National Highway Traffic Safety  
Administration

[Docket No. NHTSA 2001–11041, Notice 2]

Toyota Motor Corporation, Denial of  
Application for Decision of  
Inconsequential Noncompliance

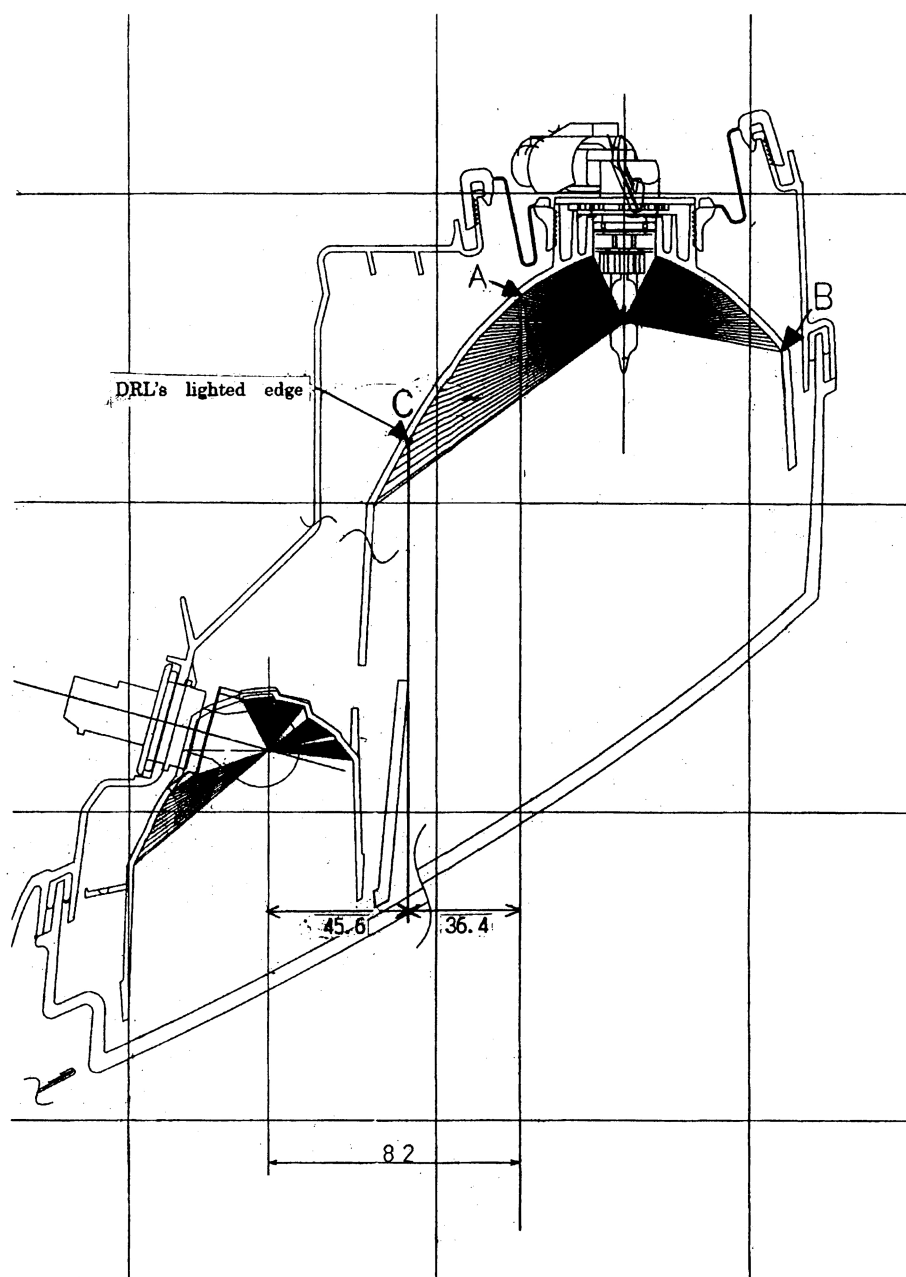
The substantial distance from the turn signal optical center (bulb filament axes) to the DRL’s lighted edge is 82 mm, exceeding 80% of the requirements. In this case, the “substantial” distance refers to the distance from the turn signal’s optical center to the actual lighted edge “A” [as shown in the figure below], although the theoretical lighted edge is point “C” (45.6mm). In [the figure below], the lighted range from A to C of the reflector emits only light which is parallel to the axis of the DRL, which can only be seen by drivers in oncoming vehicles that are looking along the optical axis of the DRL. However, as one moves off center, this light is no longer visible. Therefore the perceptible DRL’s lighted area, except for the unique case where the eye-point is on the optical axis of the DRL, is actually from A to B (as shown in the figure).

Toyota also discussed an alternative method of measuring the distance between the DRL's lighted edge and the optical center of the turn signal. The above figure outlines these two spacing measurements. Toyota stated that the spacing of 45.6 mm between the DRL's lighted edge and the turn signal's optical center (line C to the optical center) would only be seen when looking along the optical axis of the DRL. In other positions, the DRL's lighted edge (line A) would be seen by observers as being 82 mm from the turn signal's optical center. The agency does not find merit in this rationale. First, the distance measured from line A is 18 mm less than the minimum requirement. This is still a significant difference. Second, although the distance from line C to the turn signal's optical center (45.6 mm) may not best represent the DRL's lighted edge in all conditions, it does represent a worst-case scenario. The intent of the standard is to account for all possible viewing locations. Certainly, there will be situations where opposing drivers will be looking along the optical axis of the subject vehicles' DRL. For example, if a vehicle is attempting to make a left turn in front of oncoming traffic, drivers of the oncoming vehicles may be in a position where the turn signal is not visible. Mr. Johnson described a similar situation in his comments.

In consideration of the foregoing, NHTSA has decided that Toyota has not met its burden of persuasion that the noncompliance it describes is inconsequential to motor vehicle safety, and that it should not be exempted from the notification and remedy requirements of the statute. Accordingly, its application is hereby denied and it must proceed to notify and remedy as required by statute, at no cost to the consumer.
